138 EAST HASTINGS STREET (COMPLETE APPLICATION)
DE414810 - ZONE DEOD

EXECUTIVE SUMMARY

- **Proposal:** To develop a six storey mixed-use building containing commercial uses on the ground floor and 97 residential units (79 market units and 18 social housing units) above one level of underground parking having vehicular access from the lane.

DEVELOPMENT PERMIT STAFF COMMITTEE RECOMMENDATION: APPROVE

Sheet No. **A1.1**

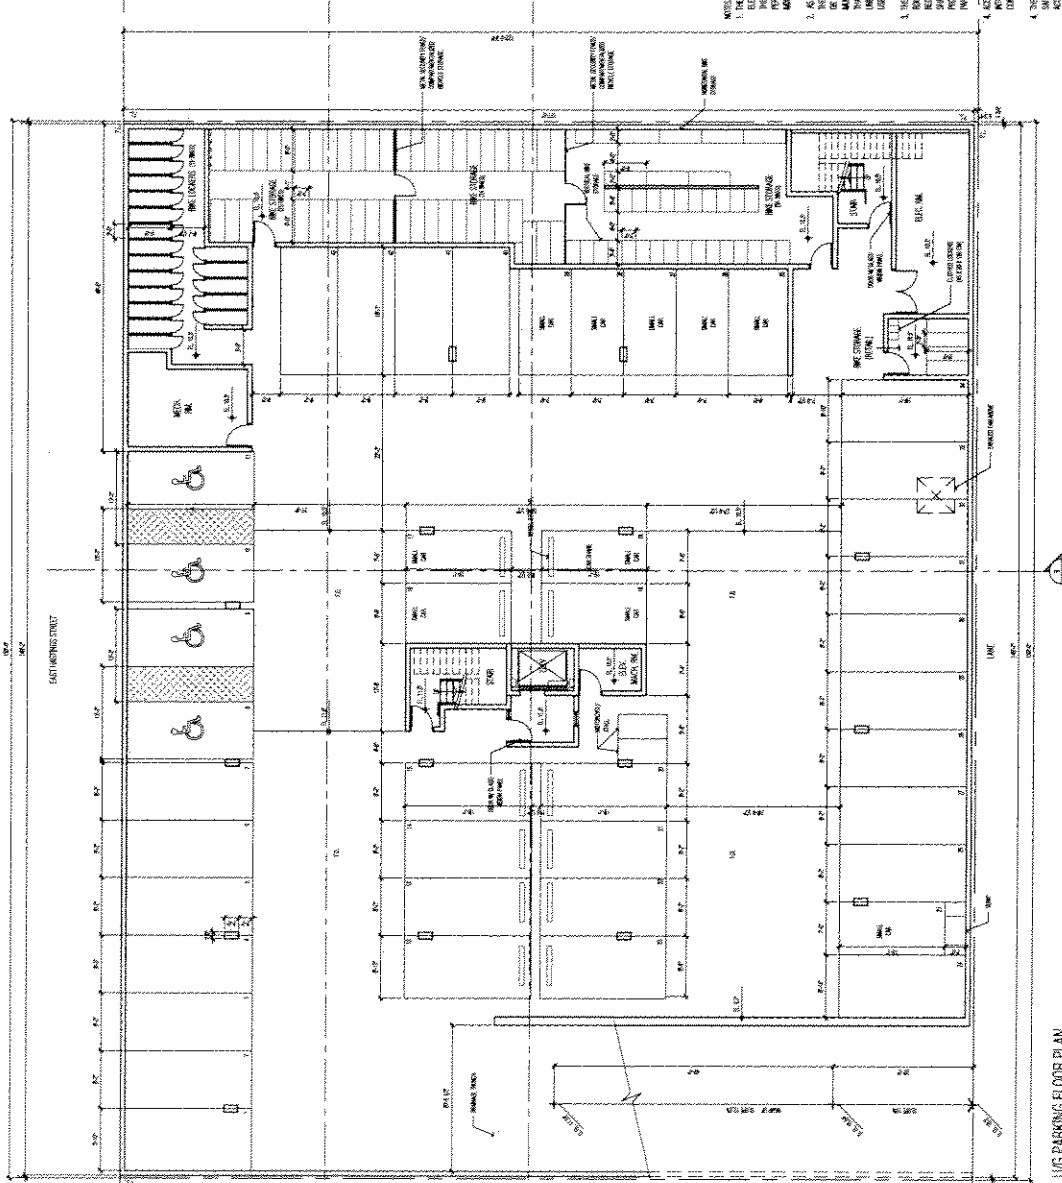
Note to Applicant: Correct design elevation on drawing A1.1 at centre-line of ramp at the property line. (Should be 18.3')
